New Mexico Oil Conservation Division approval and conditions listed below are made in accordance with OCD Rule 19.15.7.11 and are in addition to the actions approved by BLM on the following <u>3160-4 or 3160-5</u> form.

30-039-22914 AXI A #011

Re: Permanent Abandonment Well: DJR AXI Apache A11

PLUG AND ABANDONMENT PROCEDURE

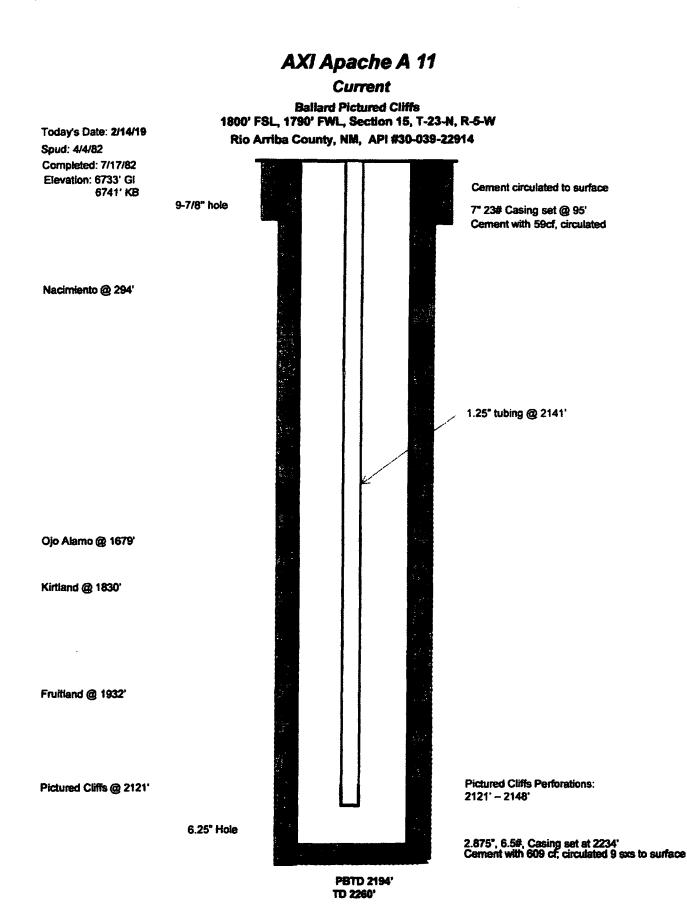
- Notify NMOCD 24hrs prior to beginning operations.
- Extend plug #1 to 2071'-1550' to cover the Ojo Alamo. OCD Ojo Alamo pick @ 1600'.

3. BLM pick: top of Ojo Alamo is 1652 ft. Modify Plug #1 to cover up to 1602 feet plus required excess.
